## **Hexham rail roads submission**

**Rick Banyard 9<sup>th</sup> September 2012**

I wish to oppose the Hexham rail project and put forward the following reasons for my objection.

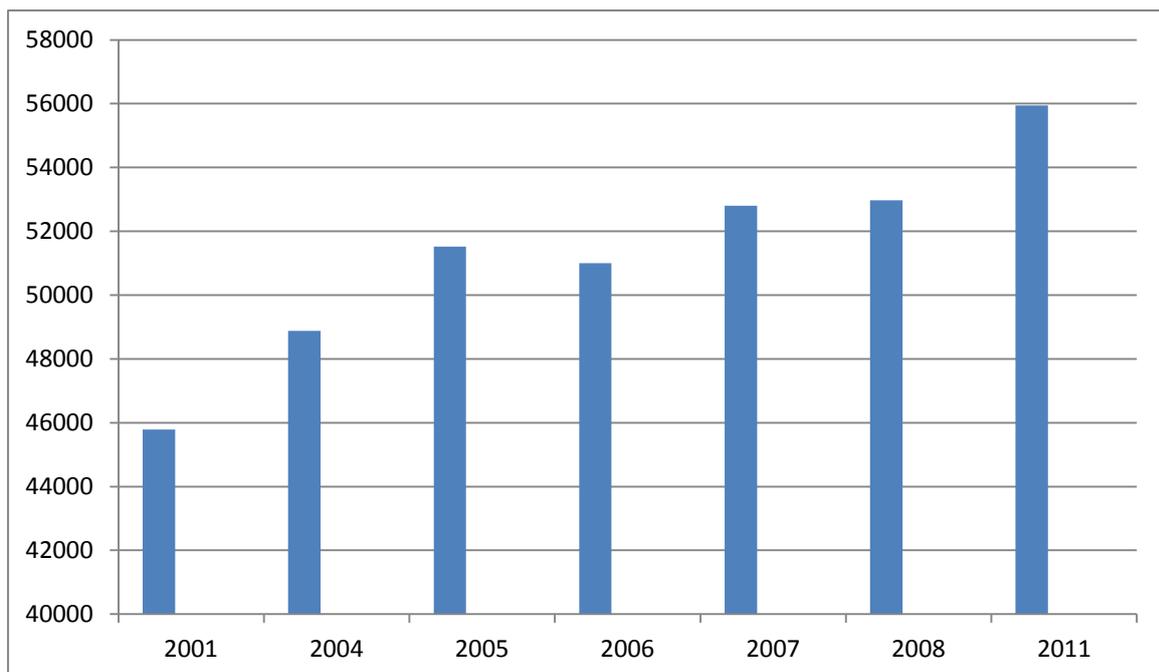
The existing traffic conditions and volumes also do not represent the current position.

Table 10.2d and e only show data up to 2008. That is four years ago.

The following table shows the position with the inclusion of the 2011 traffic volume of 55482 at count station 05.055.

Based on the construction traffic volumes 380 trips per day in table 10.3a the ADT would rise substantially to 56328. By description in the EIS most of the extra 380 trips would be heavy and very heavy vehicles.

With a major section of roadway at choke point this additional traffic will have a critical impact.

A condition of consent for the project should prohibit site traffic from entering or leaving the site between the hours of 6:30am and 9:30am from 3:30pm and 6:30 pm weekdays. To compromise Sunday, Public Holiday and up to 10pm weekdays work should be permitted.
